E-54 Regional Lift Station RFCSP
Solicitation Number: CO-00652
Job No.: 22-2502

ADDENDUM 3
April 27, 2023

SAWS JOB NO. 22-2502
 JOB NO. 11500-51
 DATE JANUARY 2023
 DESIGNER RM
 CHECKED DRAWN
 SHEET C6.01

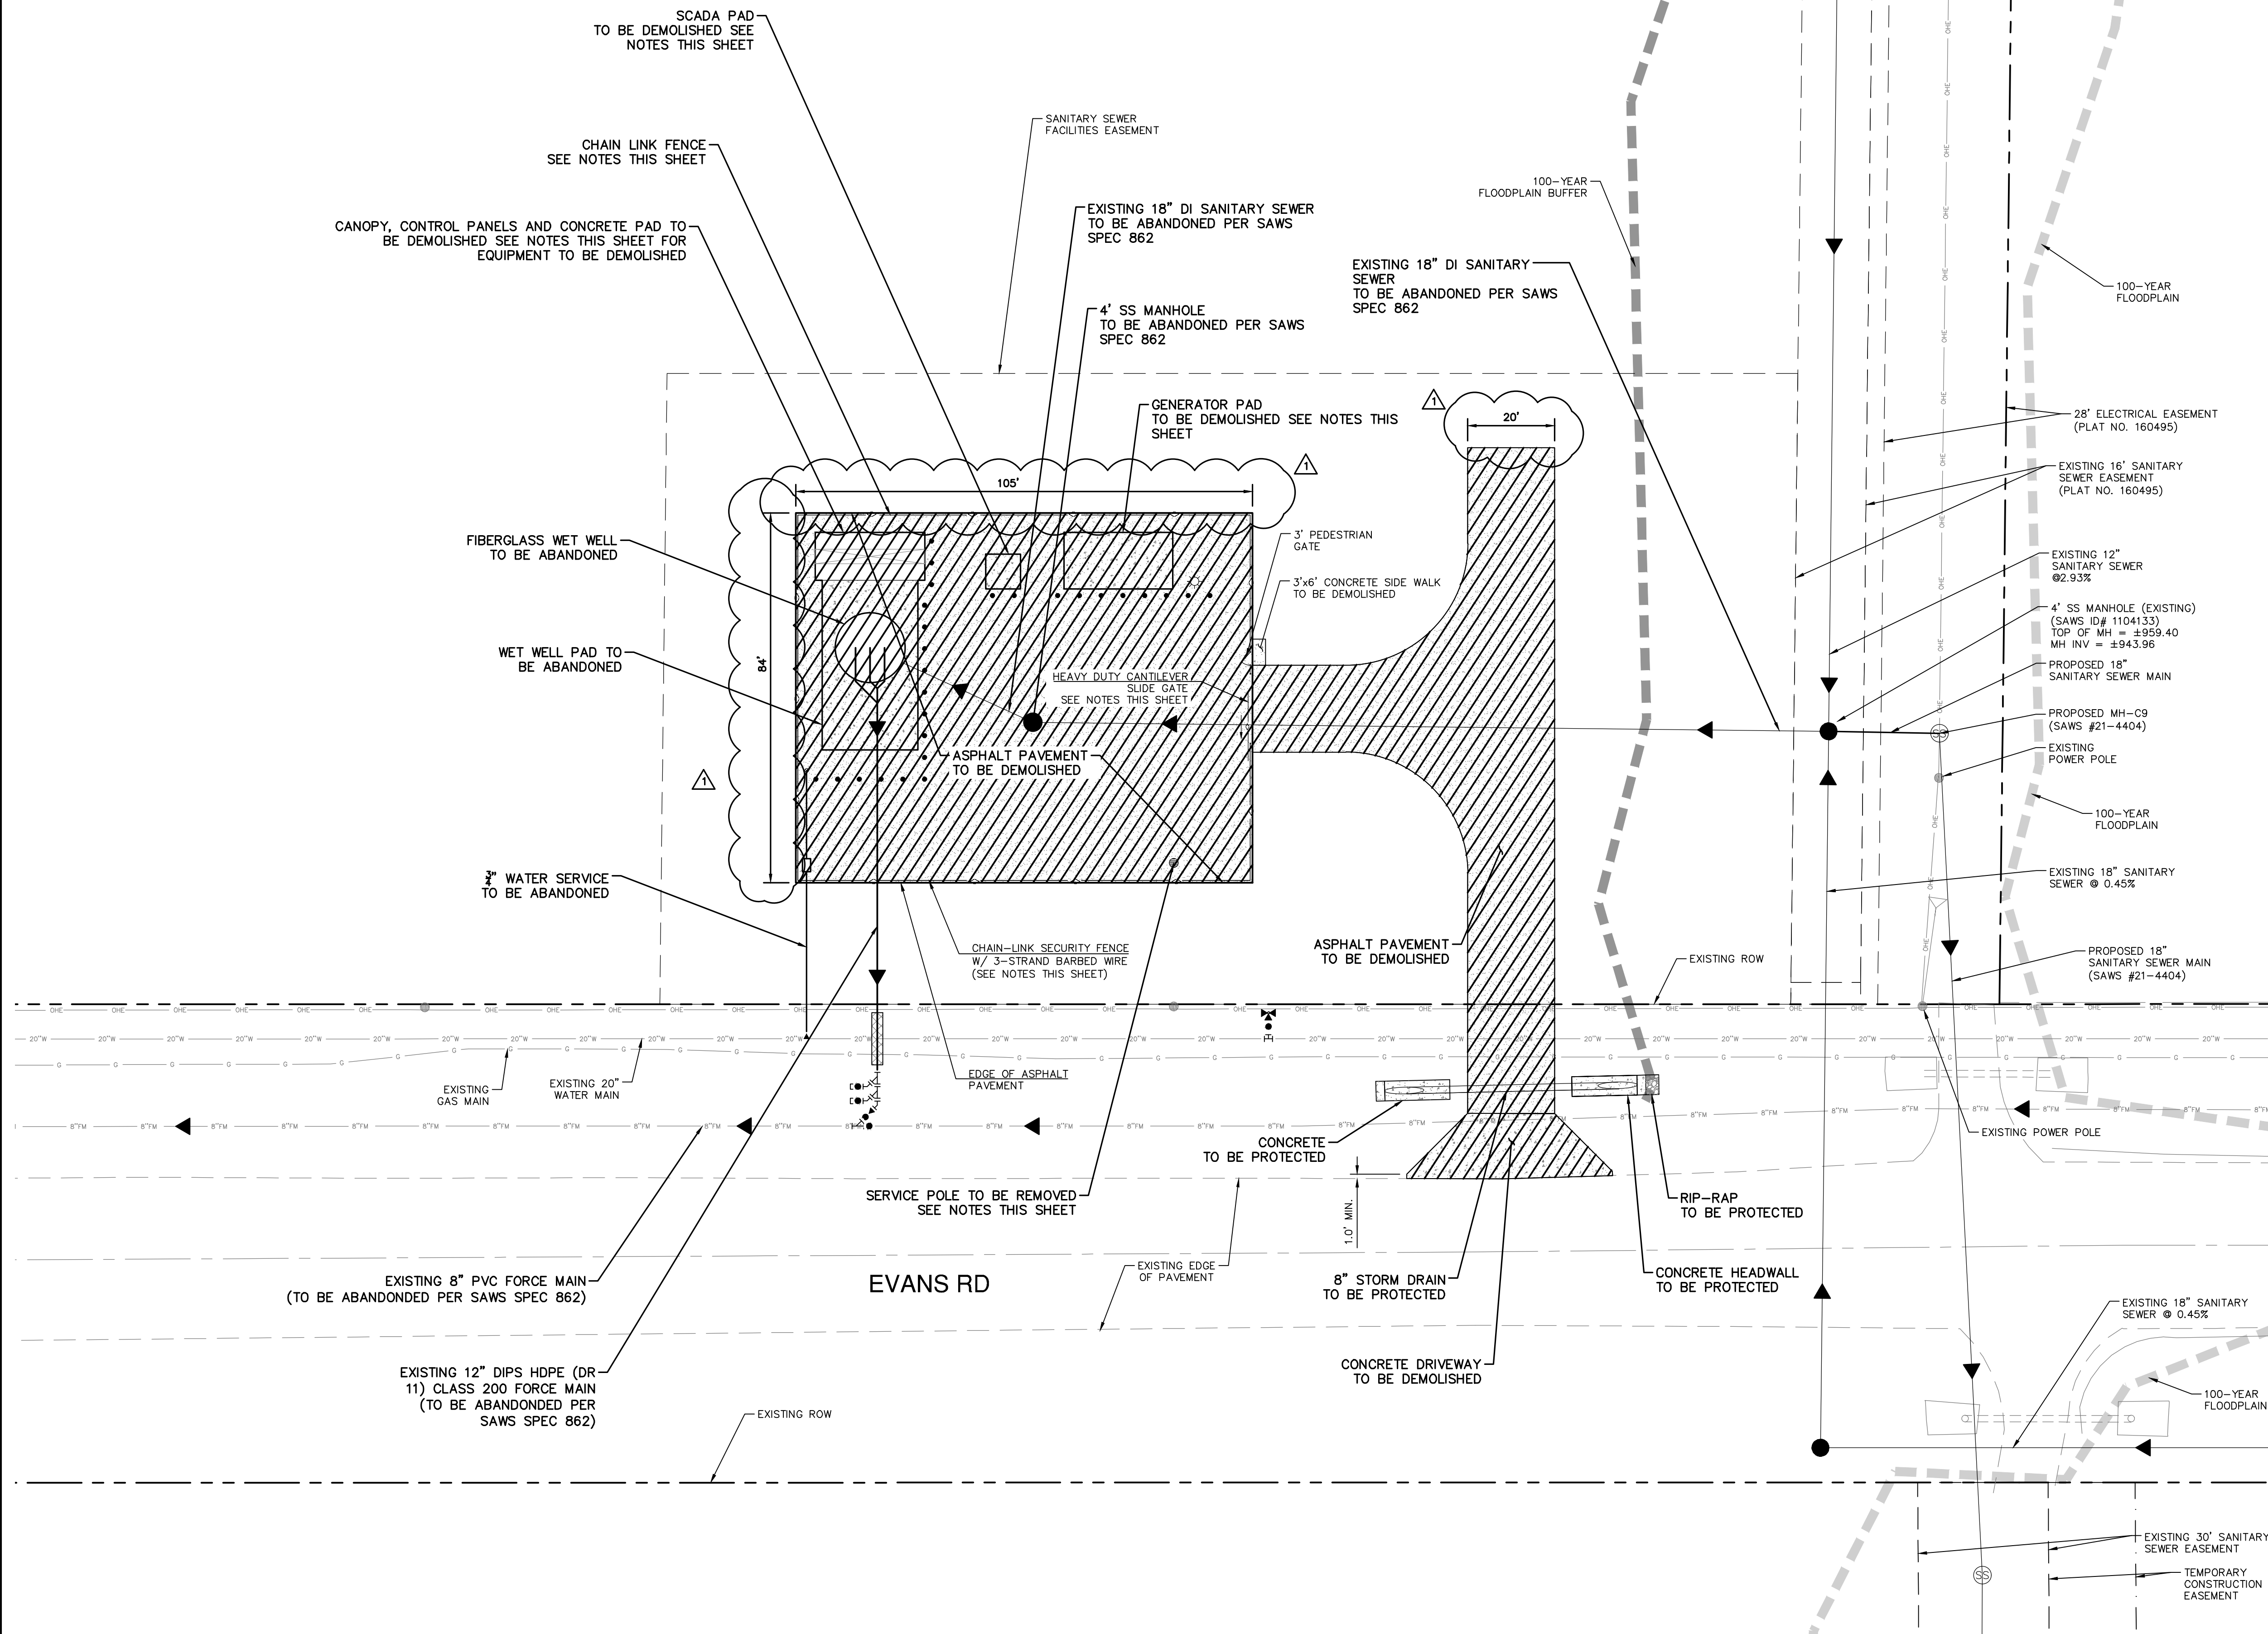
8. **Question:** Can you please provide exact internal dimensions of each lift station to be abandoned?

Response: See #1, #2, and #3 of Changes to Plans. The contractor may perform his or her own self-guided tour of the three lift stations to obtain a perimeter view.

1. Remove Sheet C6.01 in its entirety and replace with the revised version.
2. Remove Sheet C6.03 in its entirety and replace with the revised version.
3. Remove Sheet C6.06 in its entirety and replace with the revised version.

SAWS JOB NO.	22-2502
JOB NO.	11500-51
DATE	JANUARY 2023
DESIGNER	RM
CHECKED	DRAWN
SHEET	C6.06

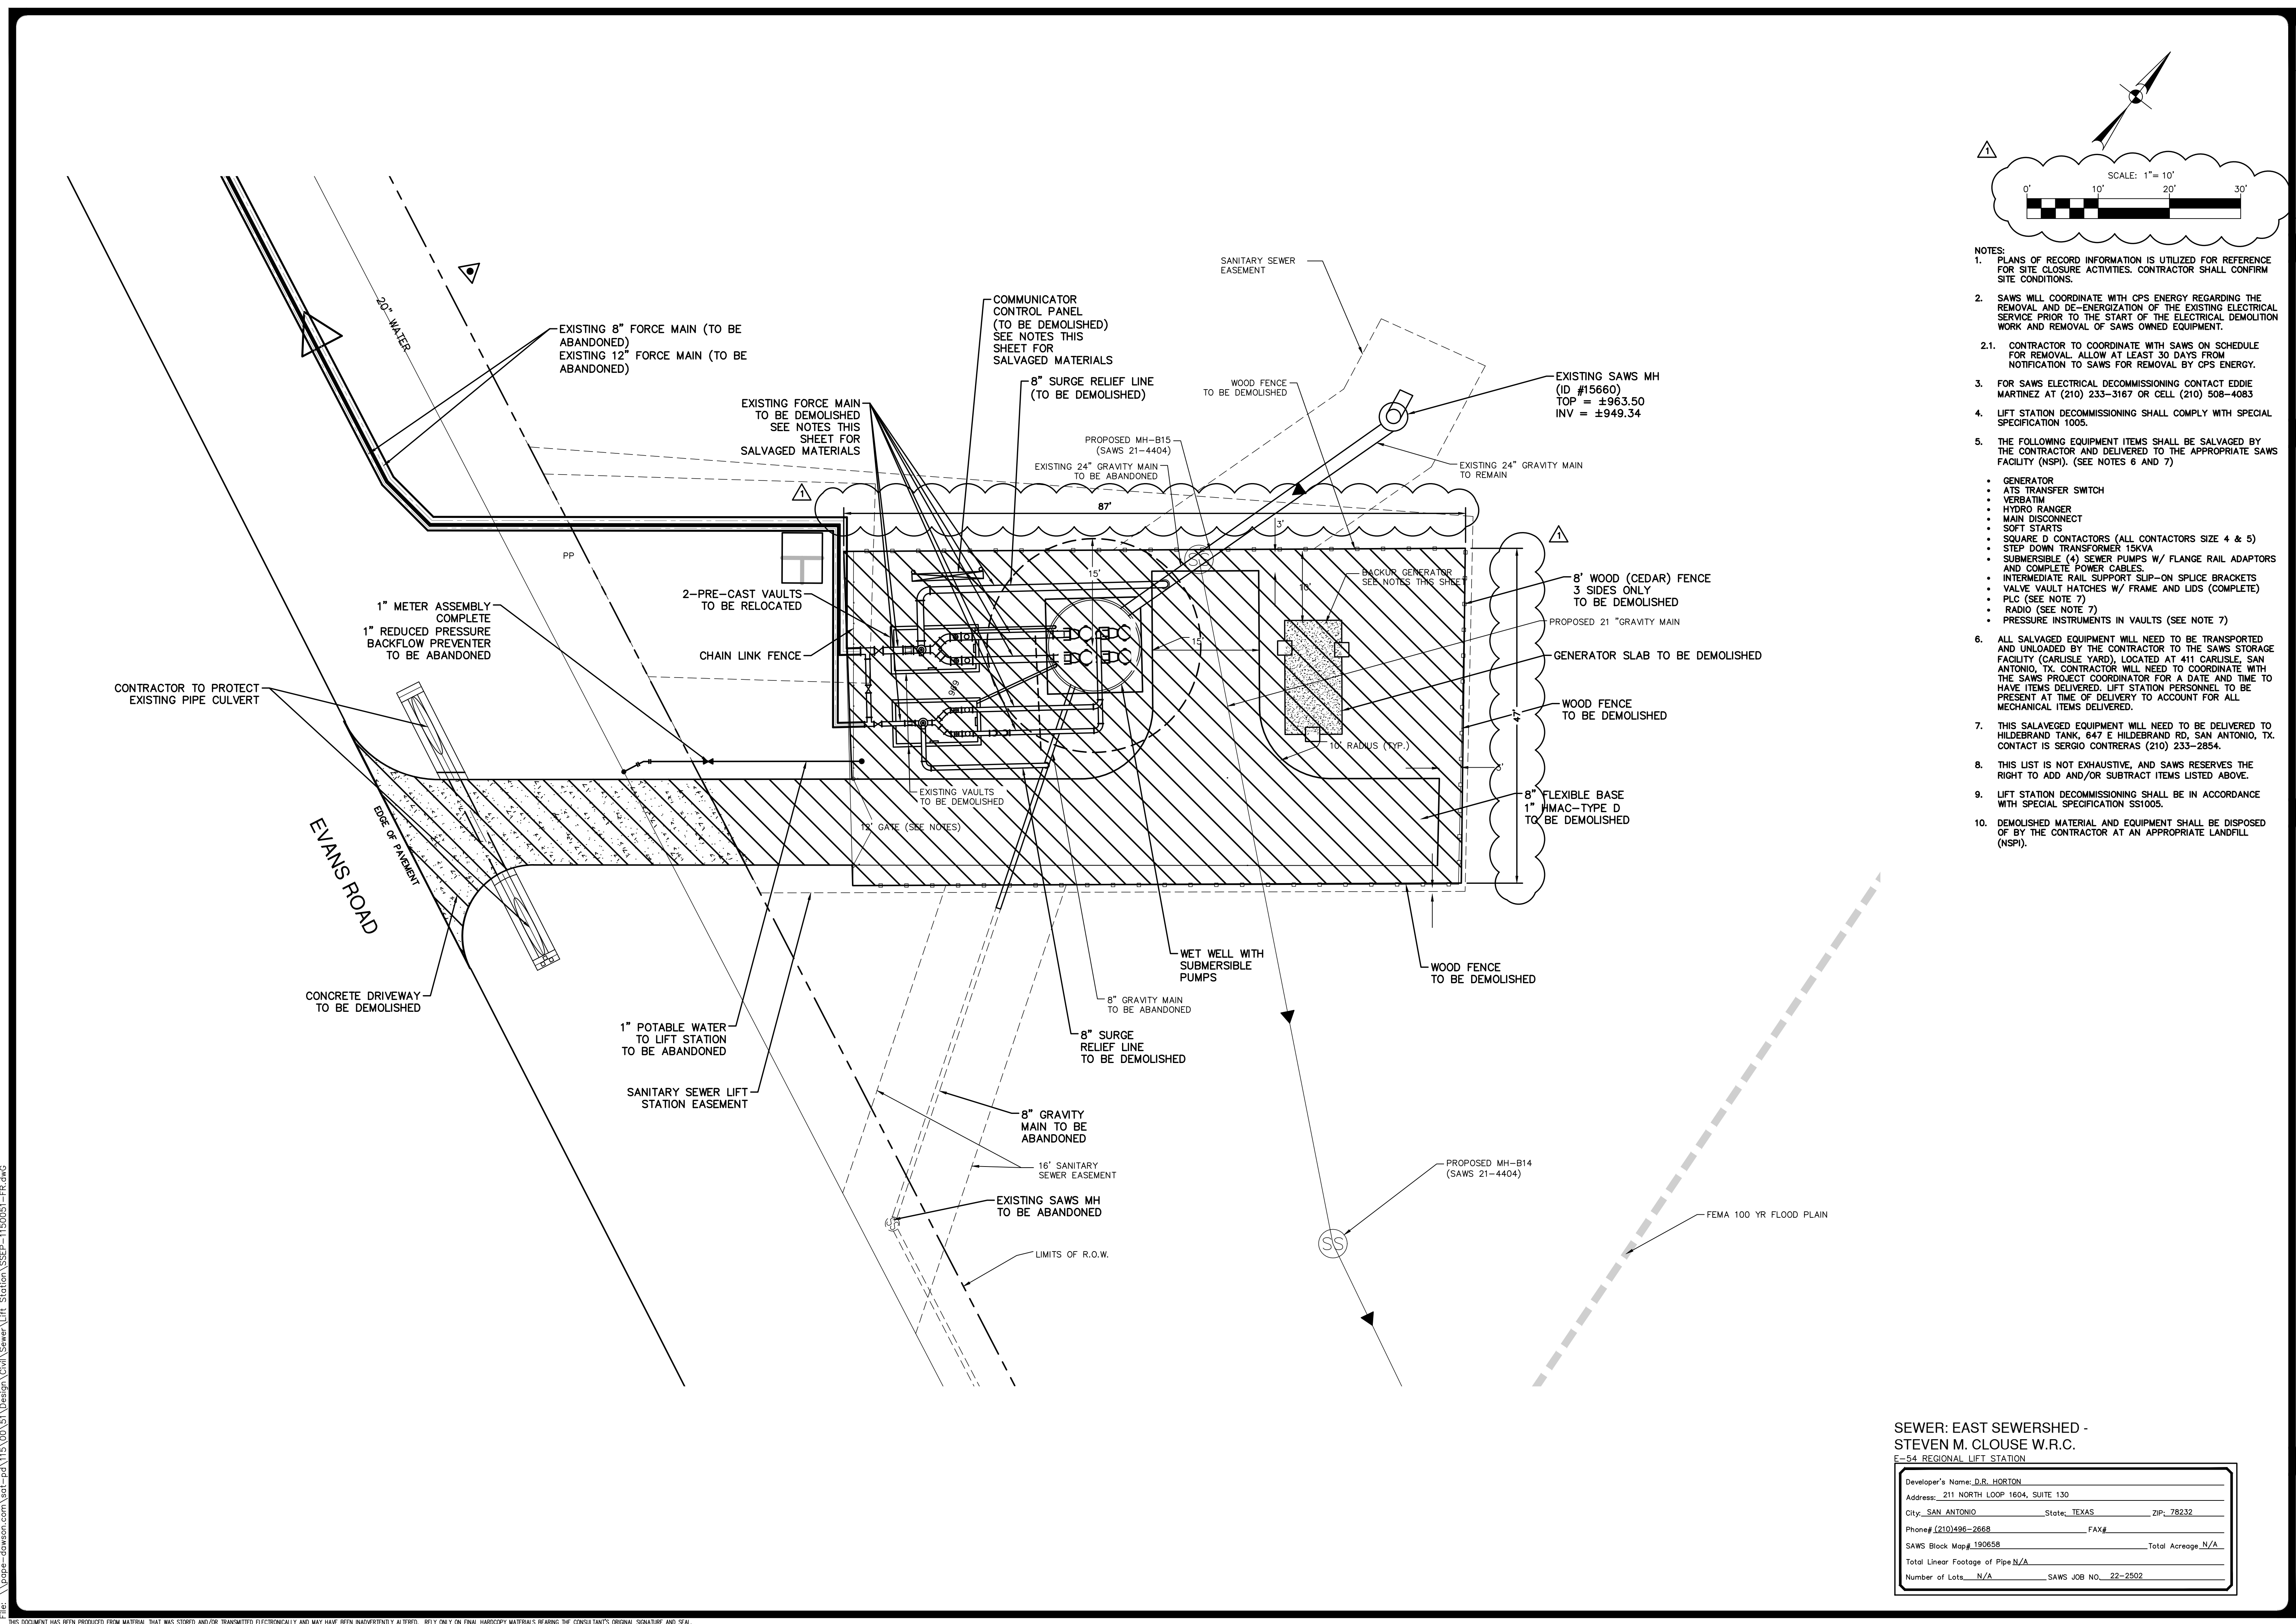
9. **Question:** Sheet C6.06 doesn't have a scale, can you please provide one?

Response: See #3 of Changes to Plans.
